**DA2024/1201 for Demolition works and construction of a dual occupancy and strata subdivision at  
286 Sydney Rd, Balgowlah**

I trust the following response satisfactorily addresses the inquiries raised in the council's letter received on 6 November 2024:

**Level 0 & Level 1 (based on a wall height of 5.8m):**

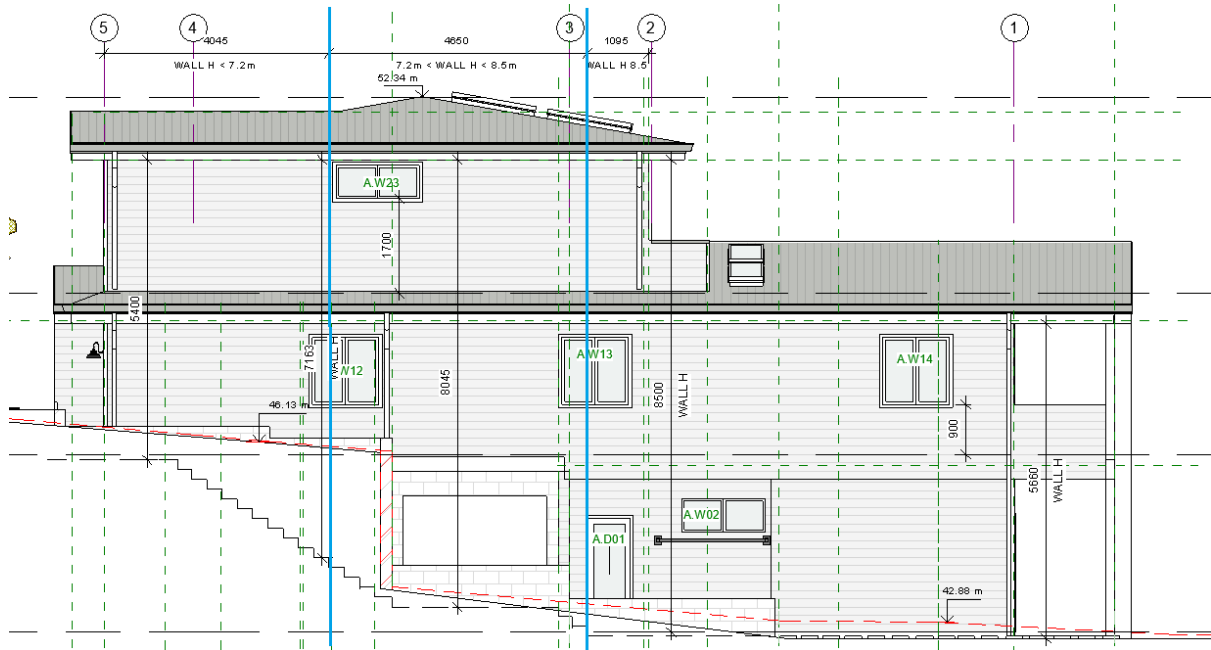
**2. Clause 4.1.4.2 - Site Setbacks and Secondary Street Frontages**

In accordance with the amendments detailed above, the setbacks between parts of the building and the site boundary have been addressed as follows:

- **Required setback:** Minimum 1.9m
- **Plans dated 24.07.2024 (DA Issue 3):** 1.4m, with a 26.3% variation

- **Revised plans dated 12.11.2024 (DA Rev):** 1.7m, with a 10.5% variation

**Level 2 (based on a wall height of 8.5m):**

- **Required setback:** Minimum 2.8m
- **Plans dated 24.07.2024 (DA Issue 3):** 2.1m, with a 25% variation
- **Revised plans dated 12.11.2024 (DA Rev):** 2.4m, with a 14.3% variation

Please note that the wall height of 8.5m applies only to a small section between grids 2 and 3. From grid 3 to grid 5 (towards the front façade), the wall height decreases, meaning the non-compliance with setback requirements affects only the Level 2 bathroom & Bed 1, with a setback variation that ranges from 0% to a maximum of 14.3%. For further clarification, please refer to the diagram on the East elevation, with mirrored dimensions on the West elevation.

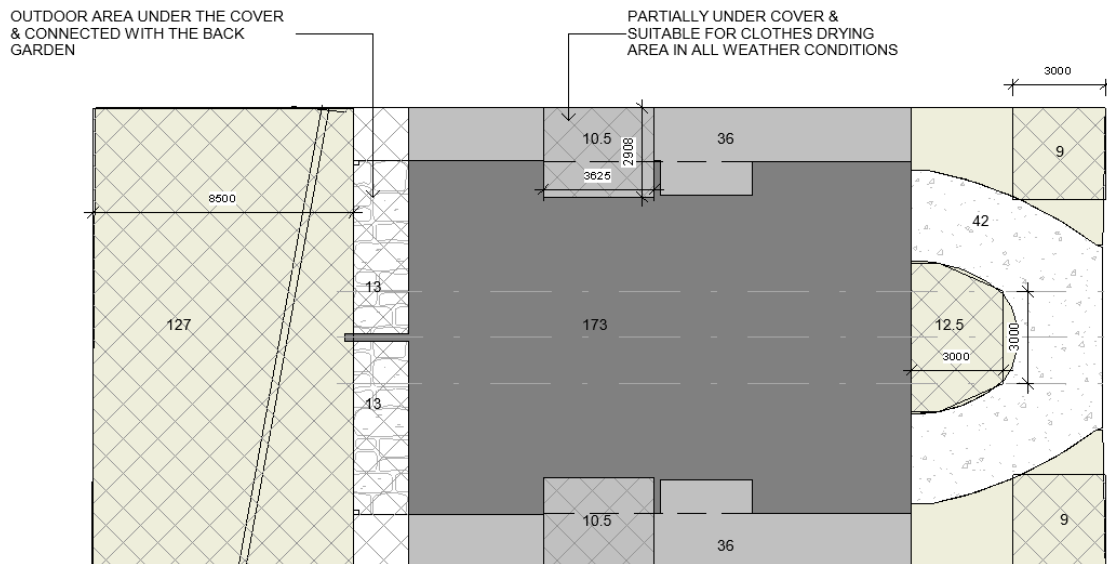
**3. Clause 4.1.5 - Open Space and Landscaping**

Following the adjustments to the building footprint and minor changes to the proposed driveway, the Open Space Area with a minimum horizontal dimension of 3m in any direction has been recalculated as shown in the attached diagram:

- **Open Space Area:**  $127 + 9 + 9 + 12.5 = 157.5\text{m}^2$  (32%), representing an improvement of 3.3%. The full  $157.5\text{m}^2$  is proposed to be landscaped.
